Point Beach Nuclear Plant, Units 1 and 2
Dockets 50-266 and 50-301
Renewed License Nos. DPR-24 and DPR-27

License Amendment Request 262
Revision to Technical Specification Operating
Limits to Include Measurement Uncertainty

LICENSE AMENDMENT REQUEST 262
REVISION TO TECHNICAL SPECIFICATION OPERATING LIMITS TO
INCLUDE MEASUREMENT UNCERTAINTY

Figure 9.10-1
High Containment Pressure – Safety Injection and Condensate Isolation Bistable
(PC-945A, 947A, 949A)

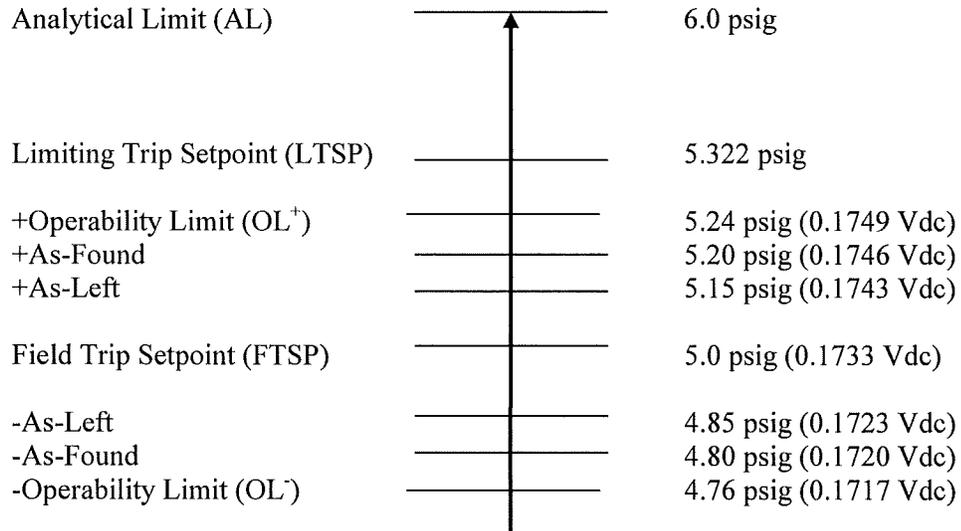
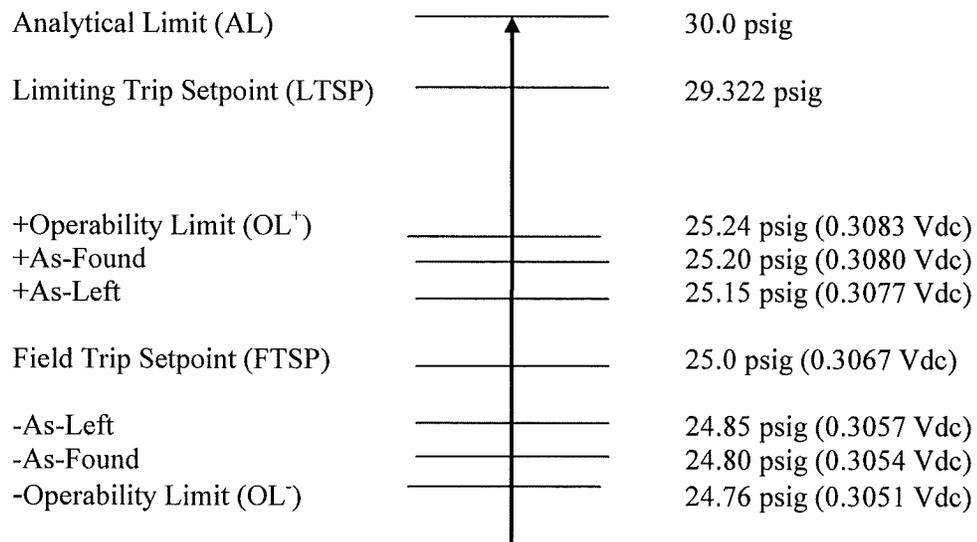
- Technical Specifications 3.3.2 (ESFAS) to be revised after NRC approval of License Amendment Request 250. Allowable Values for high and high-high containment pressure will be revised to the LTSP values shown on Figures 9.10-1 and 9.10-2. The TRM may also be revised to include the operability limits shown on these diagrams.
